TOLEDO - LUCAS COUNTY PLAN COMMISSIONS

REF: PUD-4014-22

FROM: Toledo City Plan Commission, Thomas C. Gibbons, Secretary

SUBJECT: Amendment to Planned Unit Development, Originally approved by Ord. 3-81, 198-87, & 150-16 for multi-family development at 1301 & 1302 Linden Lane

SITE PLAN

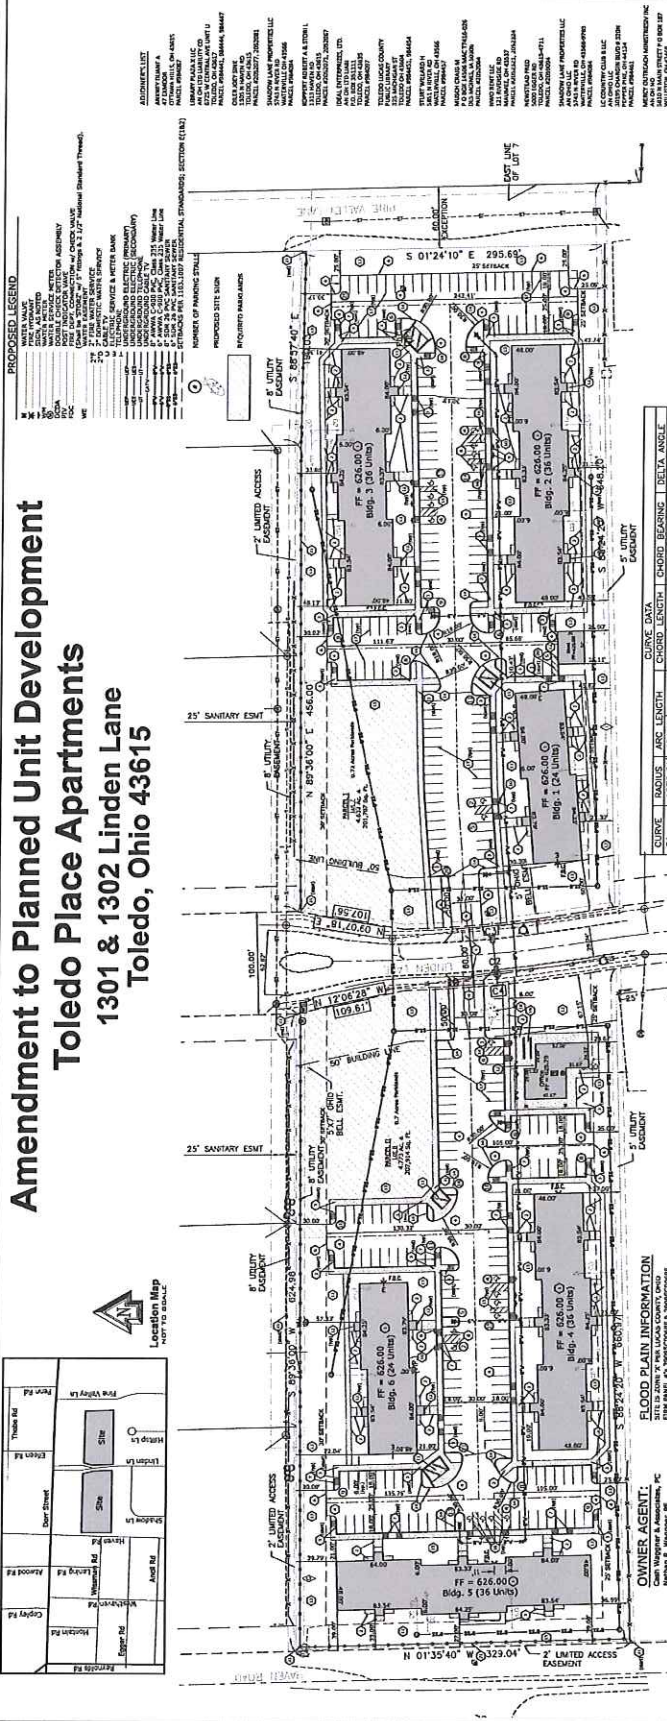
31. Per TMC§1107.0900 thirty (30) bicycle parking spaces are required. Applicant is encouraged to consider proximity to individual entrances and protection from weather when placing bike-racks due to the residential nature of the development. **None depicted – not acceptable as submitted.**

32. No more than forty percent (40%) of gross site acreage shall be devoted to coverage by buildings, structures, street pavement, driveway and parking area pavement (TMC§1106.0302(B)) **Not acceptable as depicted. A waiver shall be granted to site plan shall be adjusted.**

37. Dumpster location(s) shall be clearly defined, have a concrete pad and be surrounded by masonry screen enclosure matching building elevations with landscaping and shall not be located in any required setback. A revised site plan shall indicate material of dumpster enclosure, the location is acceptable as depicted.

38. A minimum of one litter receptacle per building-entrance from the parking lot shall be provided for the parking area. A revised site plan shall indicate location of litter receptacle.

- d. Foundation plantings along all portions of the building visible from the right of way or access drive.
- e. A six foot (6') privacy fence shall be provided along Haven Road. **Acceptable as depicted on site plan.**

- h. All parking areas visible from the right-of-way or adjacent properties shall be screened from view using an evergreen hedge line so that no headlights of any vehicles can be seen; acceptable as depicted.

- k. All parking spaces must be within 100 linear feet of a landscaped area; acceptable as depicted.
- l. Topsoil must be back filled to provide positive drainage of the landscape area.

ELEVATIONS

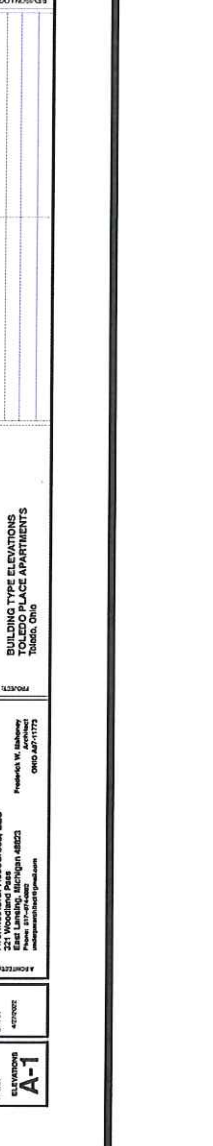
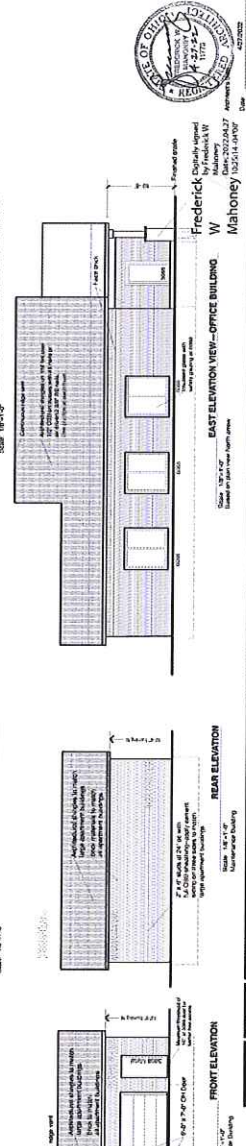
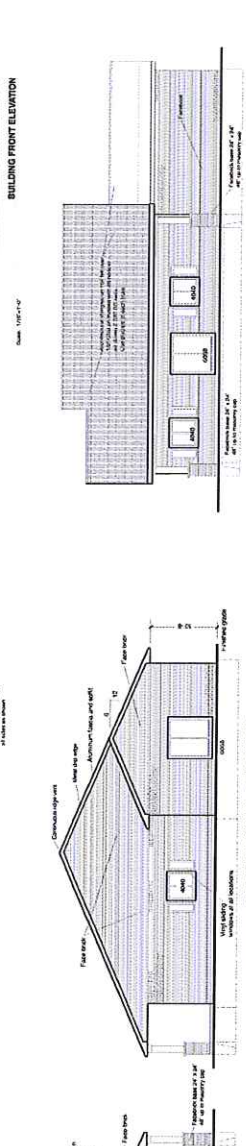
The intent of building design standards is to ensure a base level of quality architecture that contributes to the established architectural character of an area. The proposed elevations are primarily composed of a brick façade. Painted cement beveled siding is utilized as an accent material near balconies and the gable of the roof. A percentage-based breakdown of materials shall be required for review and approval by the Director per TMC§1109.0502. Each unit is serviced by a wall mounted air condenser visible from the exterior. Entrances shall be required to include architectural elements that emphasize the entrance, including but not limited to front porches, transom and sidelight windows, decorative trim and molding, and arches. Sidelight windows are provided, however additional elements shall be required such as the addition of a transom.

Furthermore, building design is required to be subdivided into human scale proportions in order to harmonize with surrounding residential development. The use of a treatment such as a belt course, change in brick course, quoins or other delineation shall be required to better match surrounding character. Final building design shall be subject to Plan Director Approval.

39. The building design shall meet the requirements of TMC§1109.0500 Building Façade Materials and Color. Elevations depicting the percentage of materials used per elevation per building shall be submitted. An architectural element to differentiate massing and better match residential character of the area shall be added. Revised building elevations shall be submitted for Plan Director Approval.
